LEES LANE SUBDIVISION

APPLICATION NUMBER 6 DATE June 7, 2018

REQUEST Subdivision

DETAIL SITE PLAN

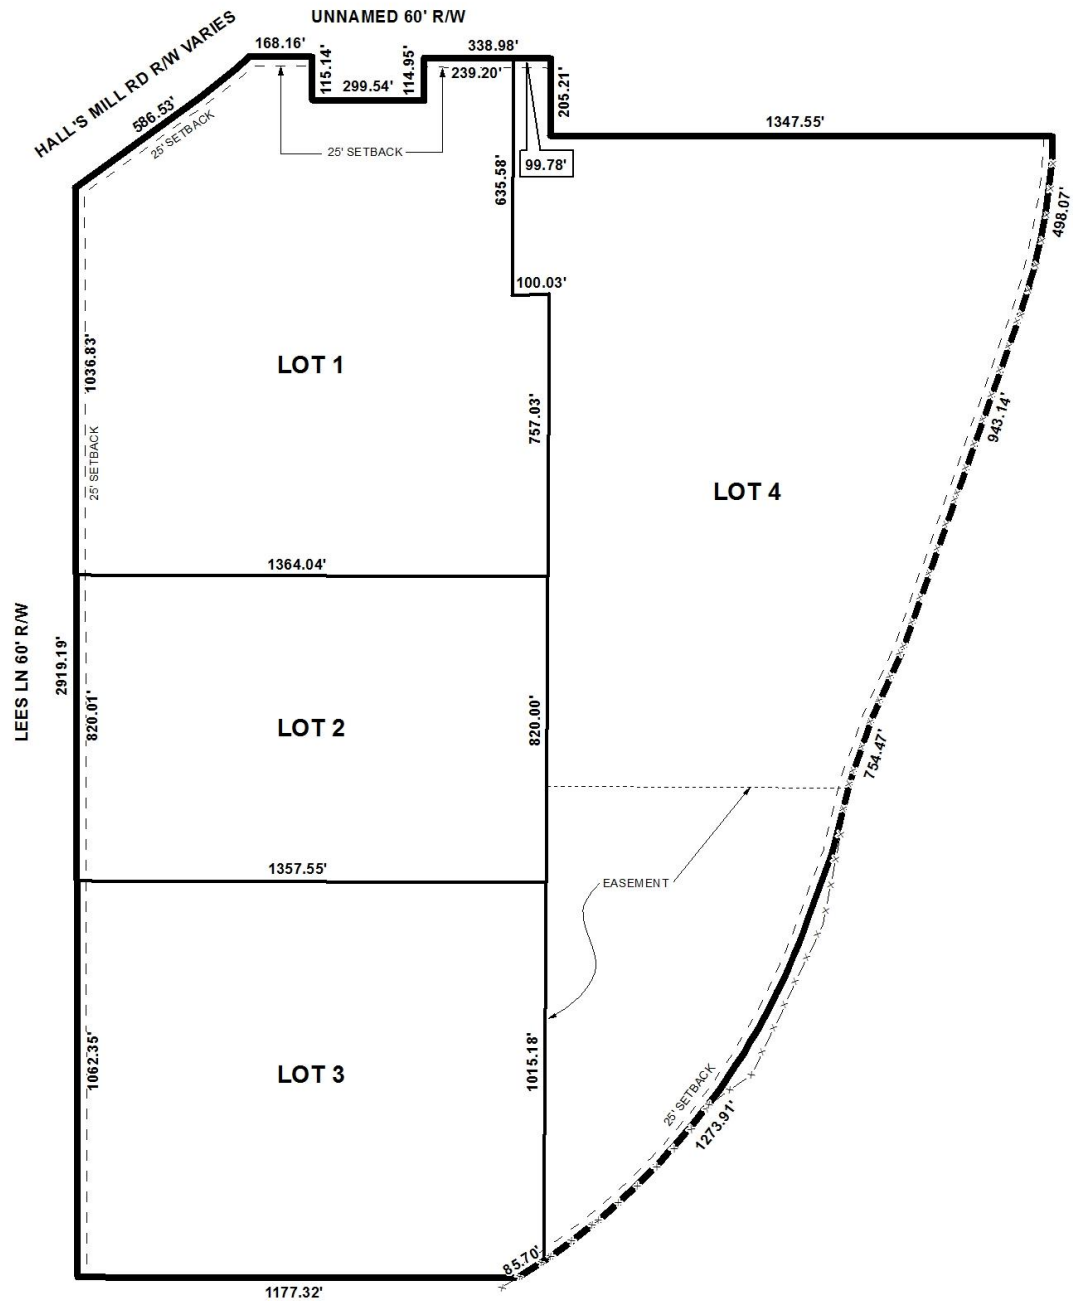
- A. Provide all of the required information on the SUBDIVISION PLAT (i.e. signature blocks, signatures, certification statements, written legal description, required notes, legend, scale, bearings and distances) that is required by the current Alabama State Board of Licensure for Professional Engineers and Land Surveyors.

- B. Include a written description of the proposed subdivision boundary in the written legal description.
- C. Dedicate the corner radius (25' minimum or as approved by the City Engineer and Traffic Engineer) at the intersection of Halls Mill Rd. and the UNNAMED ROW and at the intersection of Lees Lane and Halls Mill Rd.

- D. Provide a drainage easement for McCullough Bayou that flows across a portion of LOT 4. The extents of the easement will need to be established in conjunction with the City Engineer prior to submitting the Final Plat for review or signature.

- E. The UNNAMED ROW is currently unopened and unimproved. Any access to LOT 4 must provide an acceptable, paved access to Halls Mill Rd. Any work within the public ROW will require a ROW Permit from the Engineering Dept.

- F. National Wetlands Inventory (NWI) mapping, as shown on City of Mobile GIS information, indicates that there is potential for wetlands within the property or properties shown on this plat. Show and label the delineated wetlands, or provide a note that the wetlands shown on this plat are scaled from the NWI data and have not been delineated.

- G. Provide a note that a 25' riparian buffer may be required, during development, along the edge of anything considered by ADEM to be a water of the state.

- H. Provide and label the monument set or found at each subdivision corner.
- I. Provide the Surveyor's, Owner's (notarized), Planning Commission, and Traffic Engineering signatures.

The proposed lots front Halls Mill Road; Lees Lane; Interstate 65; and an unnamed, unimproved right-of-way. Halls Mill Road is designated as a "minor arterial" street on the Major Street Plan that should have a right-of-way of 70 feet. The preliminary plat depicts Halls Mill Road as having a right-of-way that varies; the plat should be revised to depict the minimum existing right-of-way width, and if necessary dedication will be required to provide 35 feet from the centerline where the right-of-way is not compliant. Lees Lane and the unnamed, unimproved street are both minor roads with existing rights-of-way of 60 feet, making no dedication necessary. Interstate 65 should have a right-of-way of 300 feet, and is depicted a varying; the plat should be revised to depict the minimum existing right-of-way width, and if necessary, dedication will be required to provide 150 feet from the centerline. Furthermore, dedication of

the corner radii at Halls Mill Road and Lees Lane as well as Halls Mill Road and the unnamed right-of-way per Section V.D.6. of the Subdivision Regulations should be required.

It should be noted that the proposed Lot 4, as proposed, will be split zoned R-1, Single-Family Residential and B-3, Community Business District. Therefore, if the Subdivision is to be recorded as a single phase, Lot 4 must be rezoned prior to the signing of the Final Plat. The applicant may wish to record the plat in two phases, with Lot 4 as the second phase, so that Lots 1-3 may be recorded without delay.

As a means of access management, a note should be placed on the Final Plat, if approved, stating that Lot 1 is limited to 1 curb cut to Halls Mill Road, and 2 curb cuts to Lees Lane; Lots 2 and 3 are limited to 2 curb cuts each to Lees Lane; and Lot 4 is limited to one curb cut to the unnamed, unimproved right-of way. The size, location and design of all curb cuts are to be approved by Engineering and Traffic Engineering and conform to AASHTO standards. Direct access to Interstate 65 and Interstate 10 is denied for all lots.

- 1) Either dedication to provide 35 feet from the centerline of Halls Mill Road, or illustration that there is sufficient existing right-of-way;
- 2) Either dedication to provide 150 feet from the centerline of Interstate 65, or illustration that there is sufficient existing right-of-way;

- 3) Dedication of the corner radii at Halls Mill Road and Lees Lane as well as Halls Mill Road and the unnamed right-of-way per Section V.D.6. of the Subdivision Regulations should be required;

- 4) Retention of 25' minimum building setback line along all frontages;
- 5) Retention of the lot sizes information in both square and in acres on the Final Plat;

- 6) Placement of a note on the Final Plat stating that Lot 1 is limited to 1 curb cut to Halls Mill Road, and 2 curb cuts to Lees Lane, with the size, location and design to be approved by Traffic Engineering and conform to AASHTO standards;

- 7) Placement of a note on the Final Plat stating that Lots 2 and 3 are limited to 2 curb cuts each to Lees Lane, with the size, location and design to be approved by Traffic Engineering and conform to AASHTO standards;

- 8) Placement of a note on the Final Plat stating that Lot 4 is limited to one curb cut to the unnamed, unimproved right-of way with the size, location and design to be approved by Engineering and Traffic Engineering and conform to AASHTO standards;

- 9) Placement of a note on the Final Plat stating that direct access to Interstate 65 and Interstate 10 is denied for all lots;

- 10) Successfully rezoning Lot 4 prior to the signing of the Final Plat (either as a single phase plat or a two phase plat);
- 11) Compliance with Engineering comments: (FINAL PLAT COMMENTS (should be addressed prior to submitting the FINAL PLAT for review and/or signature by the City Engineer): A. Provide all of the required information on the SUBDIVISION PLAT (i.e. signature blocks, signatures, certification statements, written legal description, required notes, legend, scale, bearings and distances) that is required by the current Alabama State Board of Licensure for Professional Engineers and Land Surveyors. B. Include a written description of the proposed subdivision boundary in the written legal description. C. Dedicate the corner radius (25' minimum or as approved by the City Engineer and Traffic Engineer) at the intersection of Halls Mill Rd. and the UNNAMED ROW and at the intersection of Lees Lane and Halls Mill Rd. D. Provide a drainage easement for McCullough Bayou that flows across a portion of LOT 4. The extents of the easement will need to be established in conjunction with the City Engineer prior to submitting the Final Plat for review or signature. E. The UNNAMED ROW is currently unopened and unimproved. Any access to LOT 4 must provide an acceptable, paved access to Halls Mill Rd. Any work within the public ROW will require a ROW Permit from the Engineering Dept. F. National Wetlands Inventory (NWI) mapping, as shown on City of Mobile GIS information, indicates that there is potential for wetlands within the property or properties shown on this plat. Show and label the delineated wetlands, or provide a note that the wetlands shown on this plat are scaled from the NWI data and have not been delineated. G. Provide a note that a 25' riparian buffer may be required, during development, along the edge of anything considered by ADEM to be a water of the state. H. Provide and label the monument set or found at each subdivision corner. I. Provide the Surveyor's, Owner's (notarized), Planning Commission, and Traffic Engineering signatures. J. Add a note to the SUBDIVISION PLAT stating that a Land Disturbance permit will be required for any land disturbing activity in accordance with Mobile City Code, Chapter 17, Storm Water Management and Flood Control); the City of Mobile, Alabama Flood Plain Management Plan (1984); and, the Rules For Erosion and Sedimentation Control and Storm Water Runoff Control. K. Add a note to the Plat stating that the approval of all applicable federal, state, and local agencies (including all storm water runoff, wetland and floodplain requirements) will be required prior to the issuance of a Land Disturbance permit. L. Add a note that sidewalk is required to be constructed, and/or repaired, along the frontage of each lot, or parcel, at time of new development or construction, unless a sidewalk waiver is approved. M. Add a note to the plat stating that all proposed detention facilities, common areas, and wetlands shall be the responsibility of the Property Owner(s), and not the responsibility of the City of Mobile. N. Add a note to the plat stating that all easements shall remain in effect until vacated through the proper Vacation process. O. Provide a copy of the FINAL SUBDIVISION PLAT to the Engineering Dept. for review. No signatures are required on this drawing. P. After addressing all of the FINAL SUBDIVISION PLAT review comments by the Engineering Dept. provide the red-line markup, the ORIGINAL (with all other signatures) and one (1) copy of the revised original (signatures not required) of the revised Final Plat to the Engineering Department.);
